#### **IWG on DETA 4th November 2020**

# DETA - Unique Identifier – Tyre Industry Perspective & Questions

## Tyre Type Approvals Possibilities

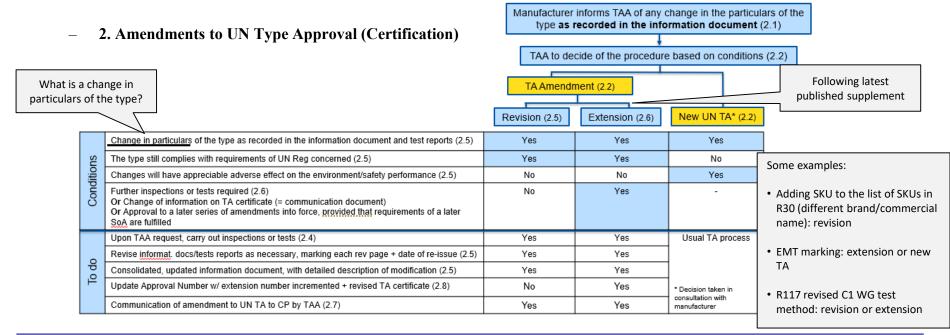
- Tyres may be certified with
  - R30/R54/R75/R106 type approval number only (exempted from R117)
  - R30/R54 and R117 type approval numbers
  - R30/R54 type approval number and by extension of the R30/R54 type approval a suffix indicating the R117 stage (S2WR2)
- For one SKU (stock-keeping unit), it is possible to have several R30 numbers
- Several SKU's may share the same combination of R30 and R117 numbers
- There is no one-to-one relation between the type characteristics as combined based on R30/R54 and R117 and the combinations of R30/R54 and R117 approval numbers
- We cannot base the product *attributes* definition on the combined tyre type characteristics

It was proposed to define the *product* as the unique combination of type approval numbers BUT...
